**OSD BUILDING 1**

RESPONSE TO SUBMISSION SUPPLEMENTARY DESIGN REPORT

## Waterloo Metro Quarter Northern Precinct OSD

## SSDA-10440

## **NORTH-WEST CORNER REDUCED BY 5.3M**

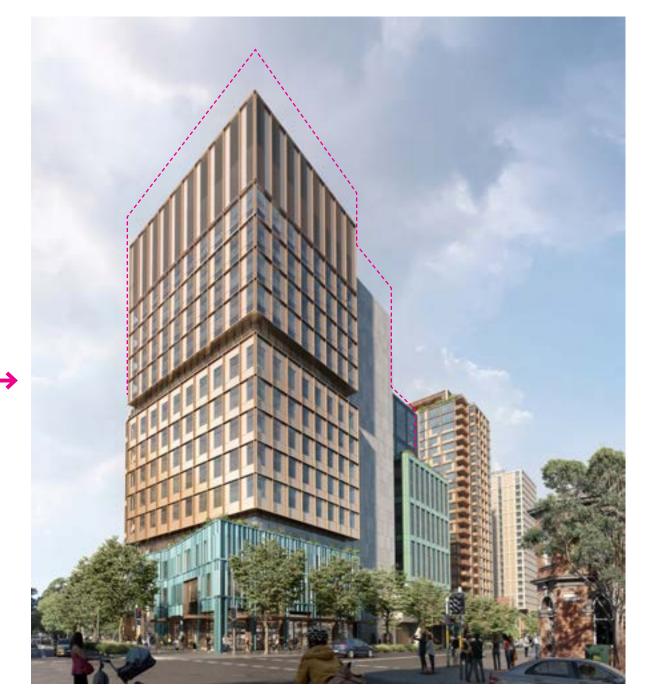
Mitigate the visual bulk of the building

The panels suggested that the design team to review the positioning of the recessed plant level to the northern most corner tower to confirm the overall proportions of the proposed built form.

- The proposed reduction of height by additional 5.3m from DA further reduces the visual impacts.
- A floor is removed, and floor to floor height is reduced.

## CORE

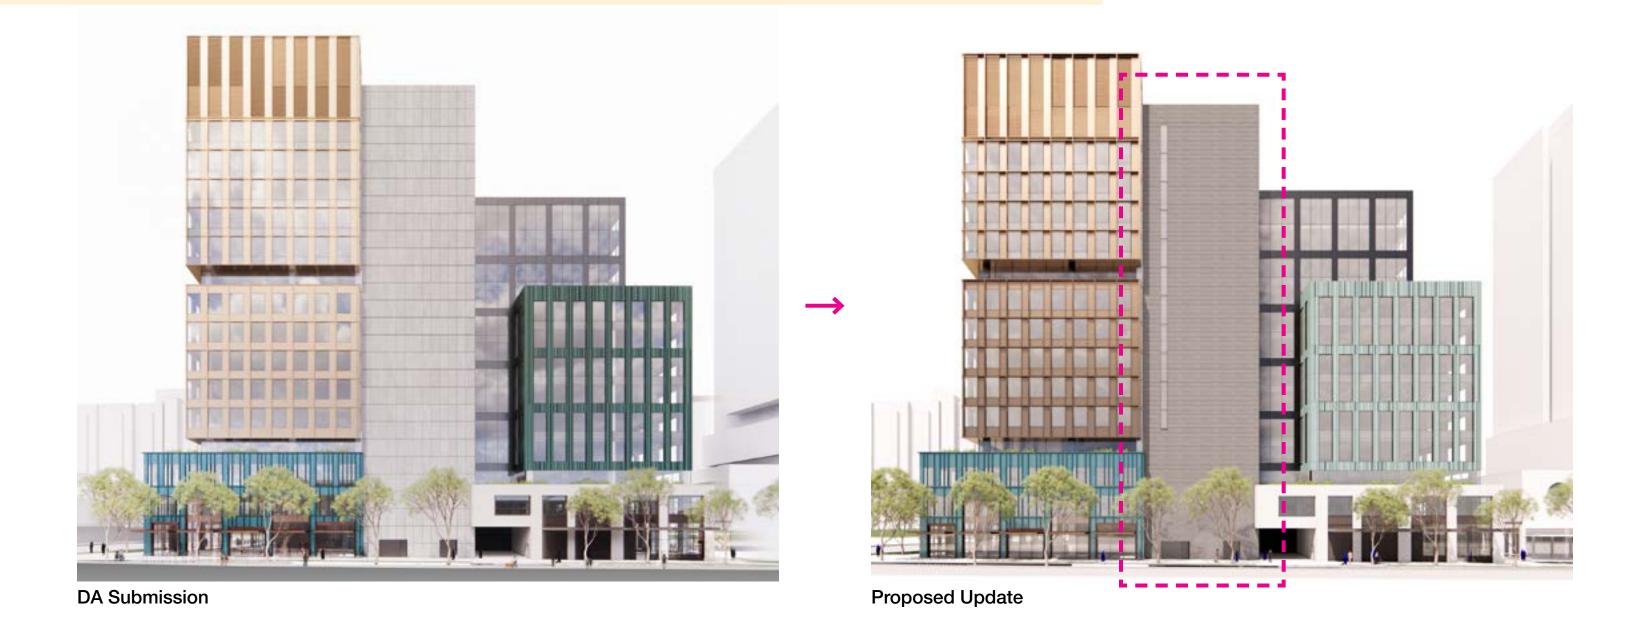
- 'Warehouse character' not achieved strongly
- Clarity on materiality
- Robustness of core cladding

- The improvement to the core cladding is proposed with additional brick layer to the podium levels enhancing masonry character of streetscape as well as providing robustness.
- Fenestration is added to the core wall providing light and views to the amenities.

#### SOLID TO WINDOW RATIO

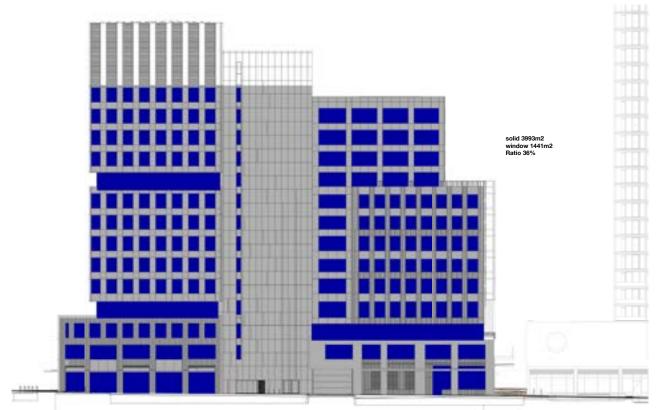
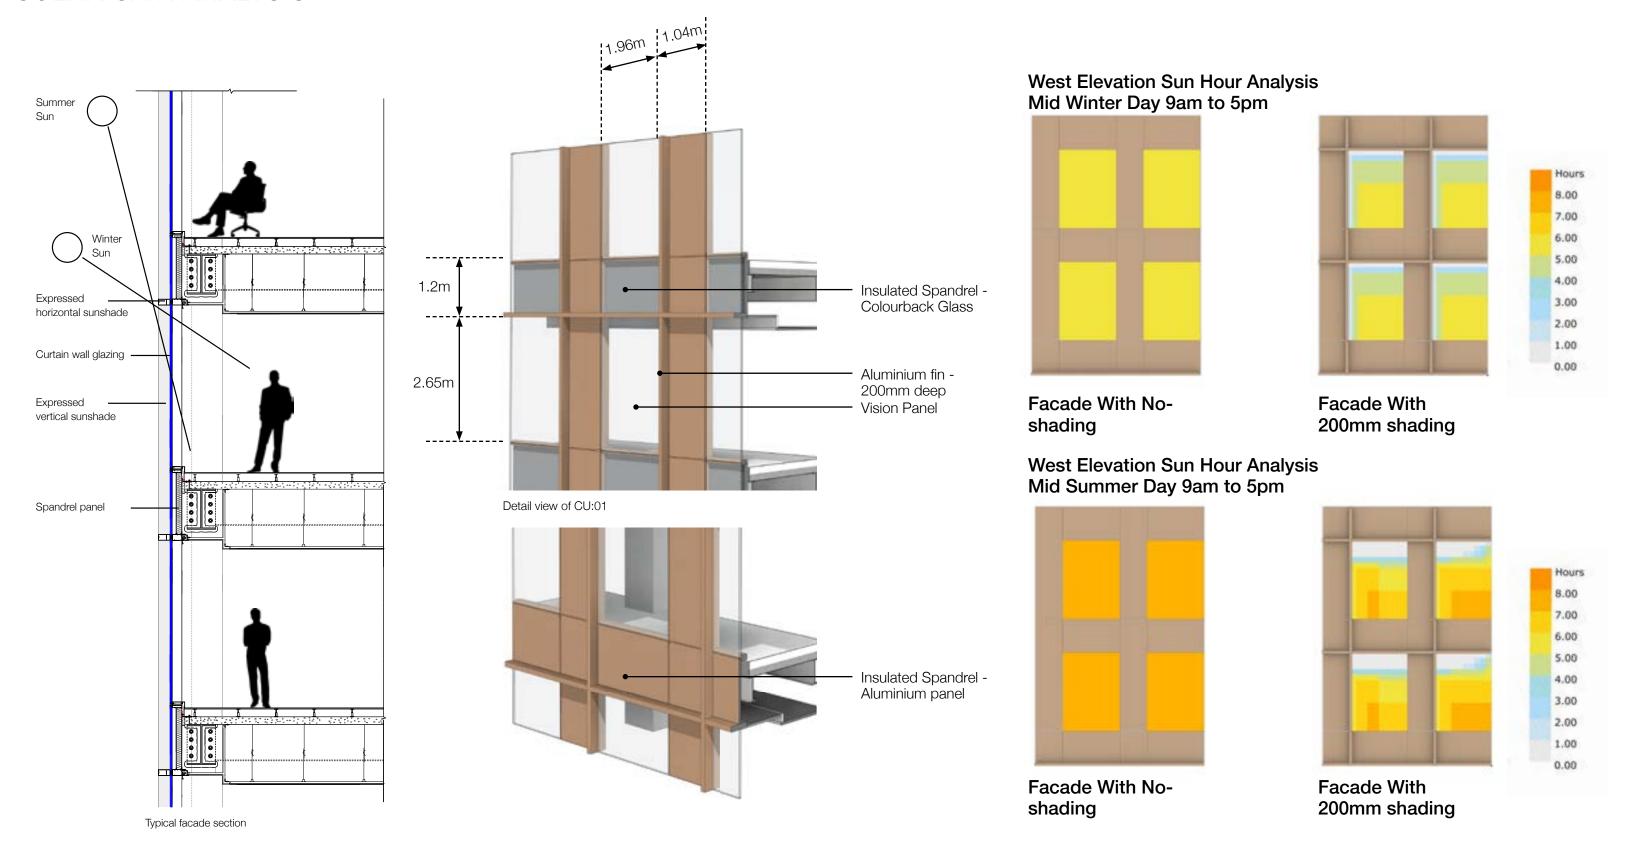
- The proposed is substantially glazed
- Unprotected west facing glazing and lack of sunshading
- Clarity on glazing specifications

The Panel recommends that the 200mm facade projection depth is reviewed during design development to improve its solar shading effectiveness

- The overall ESD strategy, including building envelopes and mechanical systems, is based on achieving a high standard of energy efficiency and comfort.
- The facade includes a large portion of insulated solid panels (circa 40% window to wall ratio) improving the building's thermal performance, which exceeds section J requirement.

West Elevation 36% Windows
North Elevation 46% Windows
East Elevation 40% Windows
South Elevation 44% Windows

## EXTERNAL STAIR ON RAGLAN WALK

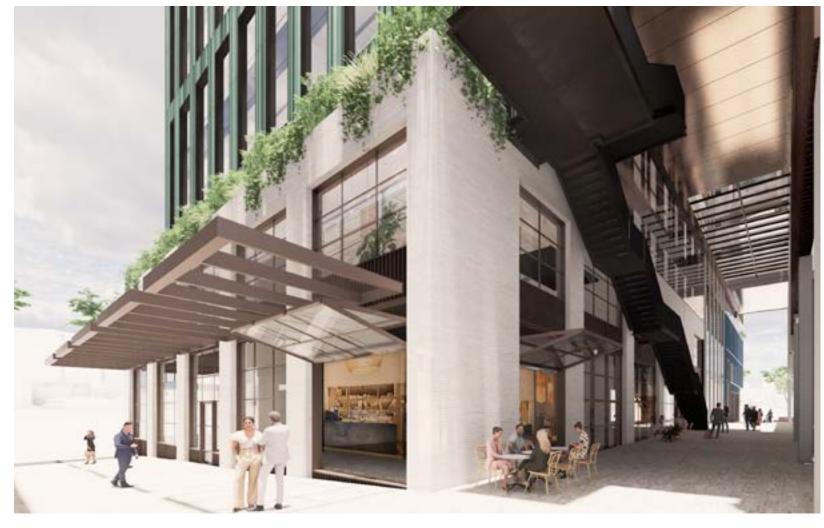
- Raglan Walk is unnecessarily encumbered
- The expression of the stair on the outside of the building's upper levels does not assist in articulating volumes and minimising bulk

- The external stair for the first two levels are internalised.
- A vestibule is created to act as an independent entry to the podium levels.
- The stair moves to the outside on level 2 to create a breakout balcony.
- A pass door is provided for emergency situations
